RE: Cossatot River High School Inspection (Polk Co)
AFIN: 57-00428 **NPDES Permit No.: ARR153654**
State Permit No.: 5178-WR-1

A R K A N S A S Department of Environmental Quality		WATER DIVISION INSPECTION REPORT					
		AFIN: 57-00428		PERMIT #: ARR153654		DATE: 8/26/2014	
		COUNTY: 57 Polk			PDS #: 079699		MEDIA: WN
		GPS LAT: 34.384607 LONG: -94.385902 LOCATION: Entrance					
FACILITY INFORMATION				INSPECTION INFORMATION			
NAME: Cossatot River High School LOCATION: 6603 Hwy 71 South CITY: Vandervoort, AR				FACILITY TYPE: 2 - Industrial		INSPECTOR ID#: 84022 S - State	
				FACILITY EVALUATION RATING: 1 - Unsatisfactory		INSPECTION TYPE: Construction Stormwater	
				DATE(S): 8/26/2014		ENTRY TIME: 14:00	
RESPONSIBLE OFFICIAL				PERMIT EFFECTIVE DATE:			
				PERMIT EXPIRATION DATE:			
NAME / TITLE: Mr. Donnie Davis / Superintendent COMPANY: Cossatot River School District MAILING ADDRESS: 130 School Drive CITY, STATE, ZIP: Wickes AR 71973 PHONE & EXT. / FAX: 870-385-7101 / EMAIL: Ddavis@cossatot.k12.ar.us				FAYETTEVILLE SHALE RELATED: N

Figure 1. Google Earth image dated Nov 13, 2012 of entire construction site. This is the most recent satellite image available.

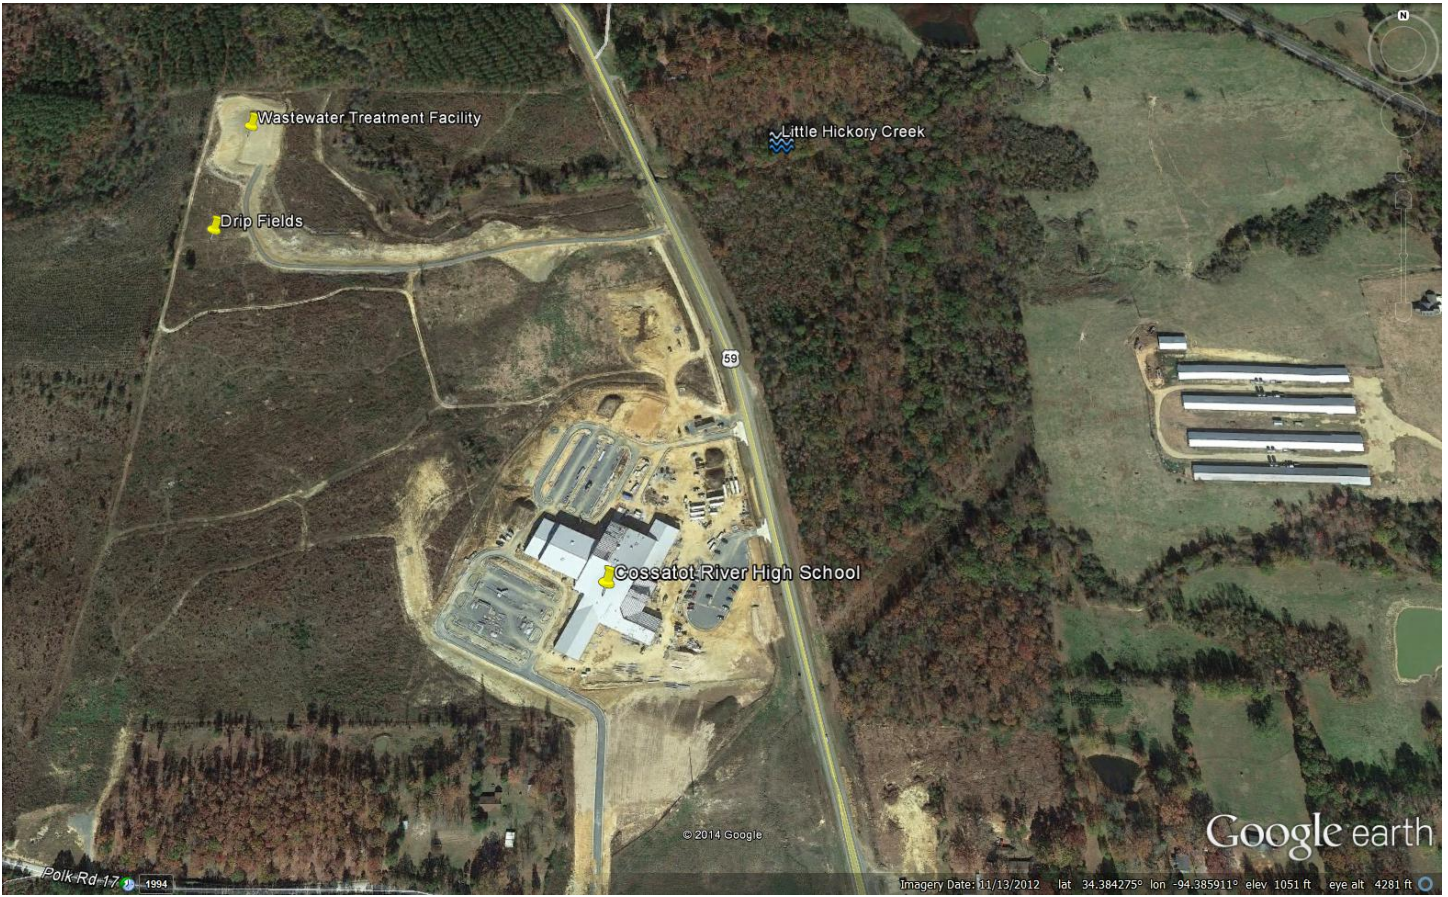
- **Site is stabilized; permit remains active**
- **SWPPP is not being updated**
- **No inspections, records of training, responsible parties, precipitation records, rain gauge, stabilization records, etc.**
- **Temporary controls (silt fence) remain onsite**
